Interactive comment on “Exceptional floods in the Prut basin, Romania, in the context of heavy rains in the summer of 2010” by Gheorghe Romanescu and Cristian Constantin Stoleriu

Received and published: 1 December 2016

Fig. 1.

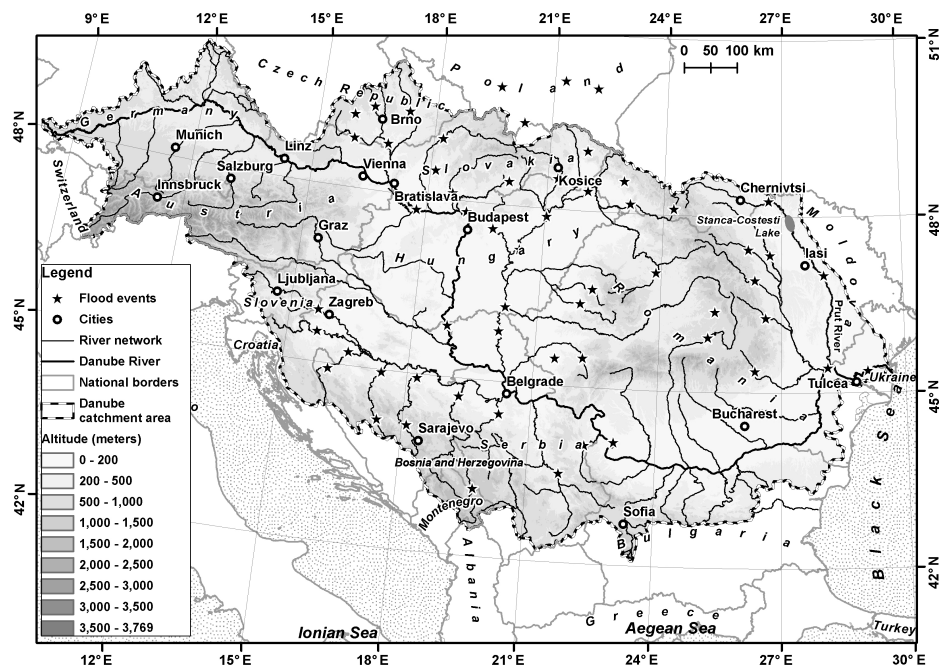
Referee comment 4: Line 61: are the Stanca-Costesti reservoir and the Prut reported in Fig. 1?

Authors' answer4: We modified the Figure 1, in order to appear River Prut, Danube and Stanca-Costesti reservoir.

Fig. 3.

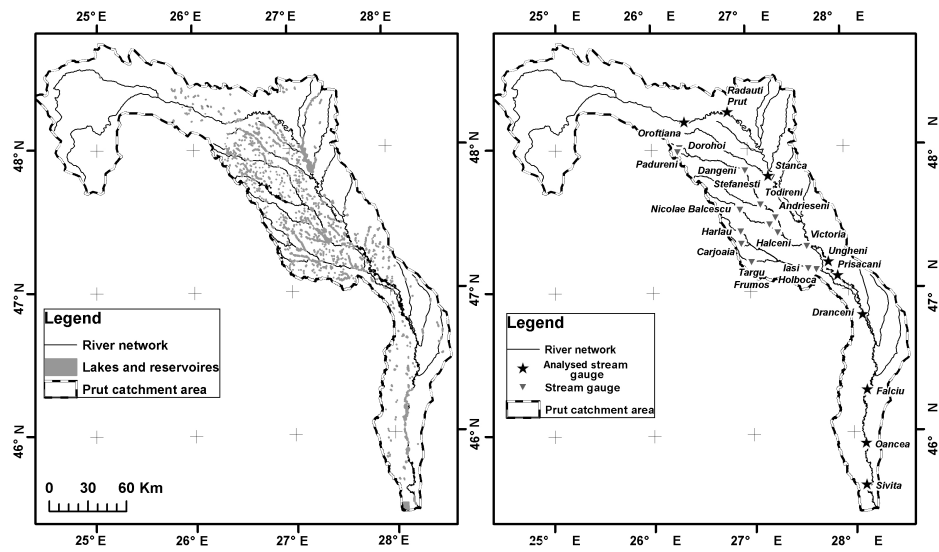
Referee comment 12: Line 168 You need to specify what is registered in each station. What do you mean by "only water levels"? the stations reported in Table 1 should be easily identified in Fig. 3 (by using a different marker) and what is observed (level or discharge should be mentioned. Fig. 5 is not easy to read Line 199 and line 203. What is meant by "floods were recorded"? Do you mean that a flood gauging was operated instead of using the rating curve?

Authors' answer12 : Figure 3 was modified by using different marker. For line 168 "At Oroftiana gauging station, only the water levels data were registered. And for all other gauging stations are registering, in addition to water level, the discharges data." For line 199 and line 203 Floods were registered at the gauging station.

Fig. 6.

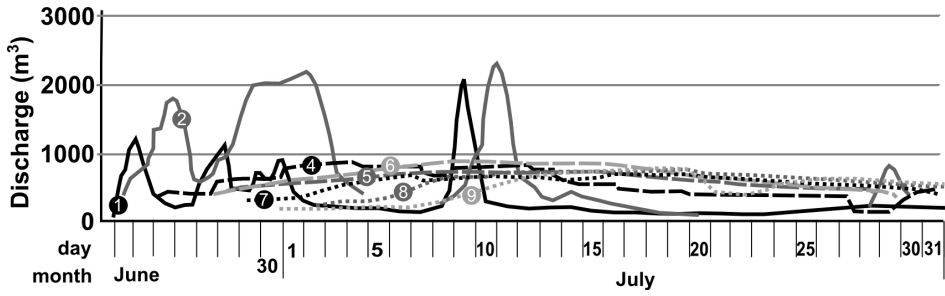
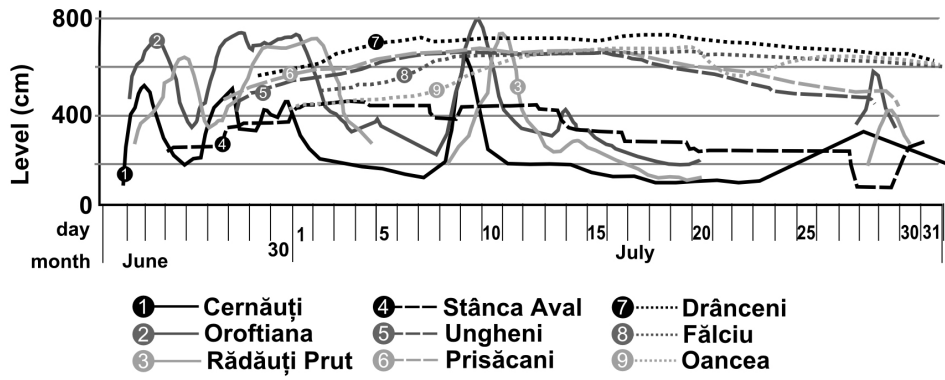
Referee comment 14: Line 243 and elsewhere "Fig. 3 and 6" is not clear. Fig 6 is not easy to read. The peculiarity of Stefanesti(?) station should be mentioned and analyzed in the text. (lines 218 to 221) In all figures, with levels and discharges plts the basin area should be mentioned as well as in lines 310-315.

Authors' answer14 : The figures were modified for a better readability. Stefanesti gaug-

ing station is located in the downstream sector of the dam and it is directly influenced by the discharge water from the Stanca-Costesti Lake (since 1978).
